Tait Confidential Tait Electronics Ltd

TECHNICAL NOTE TN-1140b TM8000 Horn Alert Operation

20th February 2006

Figure 1

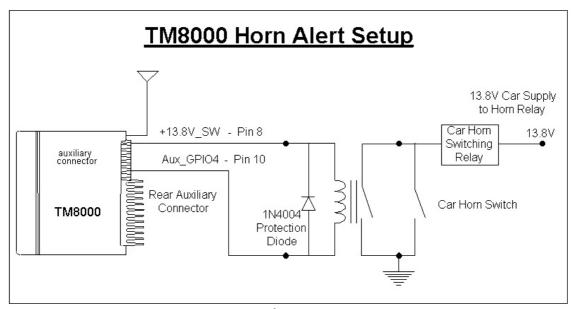
It has been found that if the radio's power supply is removed but 13.8 Volts is still being supplied to GPIO4 (via the external device) then a 'back feed' can occur causing the radio to partially power up. This can cause the Horn, or other external alert device on the output, to activate.

To prevent this from occurring another relay powered from the 13.8V switched line of the radio (Pin 8 on the AUX connector) will need to be used to switch the external device to ground upon an external alert activation.

This will then provide an isolated switched output that is not affected when the supply voltage of the radio is disconnected. It also provides an additional means of protection to the radio should the voltage at GPIO4 exceed it's safe DC input level of Supply Voltage + 0.5 Volts, such in a 24 Volt installation.

Figure 1 shows the configuration for a TM8000 horn alert setup using the additional relay.
